NOTICE OF CHANGE

ADJUSTMENT OF CYR538 RIDEAU HALL, ON

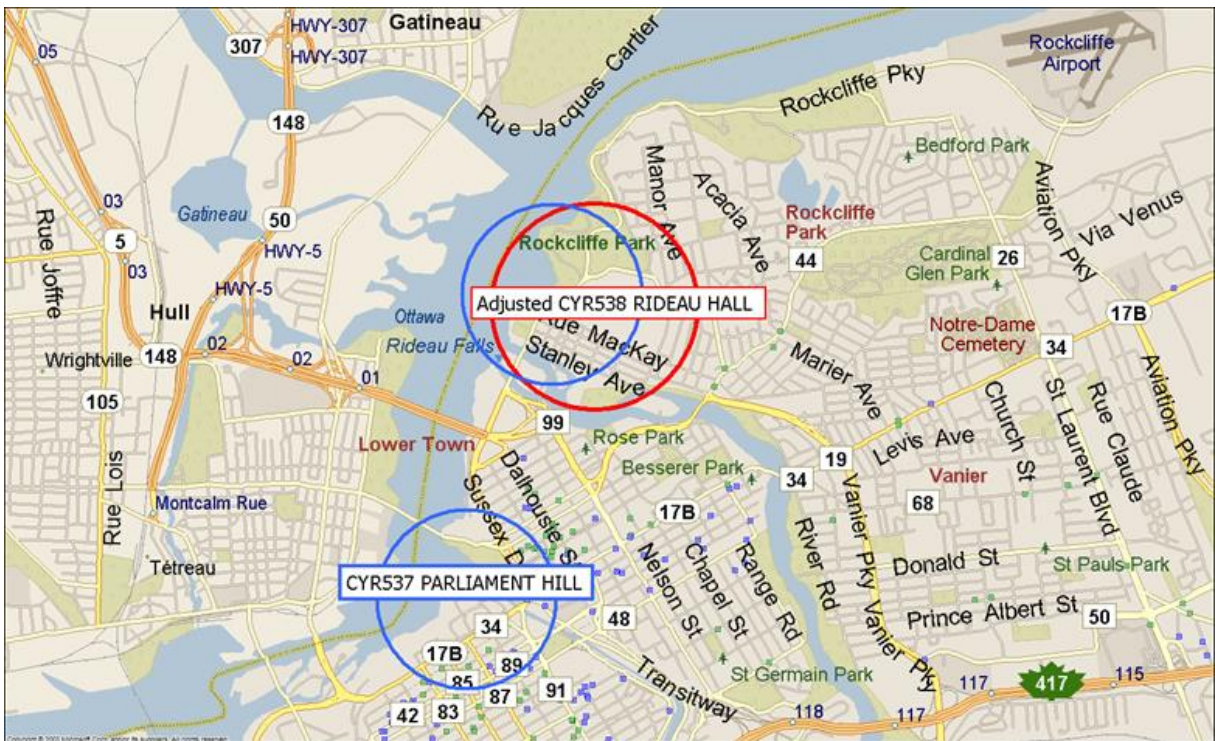
NAV CANADA, the country's provider of civil air navigation services, at the request of the RCMP has made an adjustment to the location and dimension of the restricted airspace CYR538 over the Governor General's Residence, Rideau Hall. The purpose of this change is to enhance the security of the Rideau Hall buildings and grounds.

The new dimension and coordinates are as follows: The airspace within the area bounded by a circle of 0.4 nautical mile radius centred on N45°26'38.90" W075°41'17.80", surface to 3,000' ASL (See map sketch below).
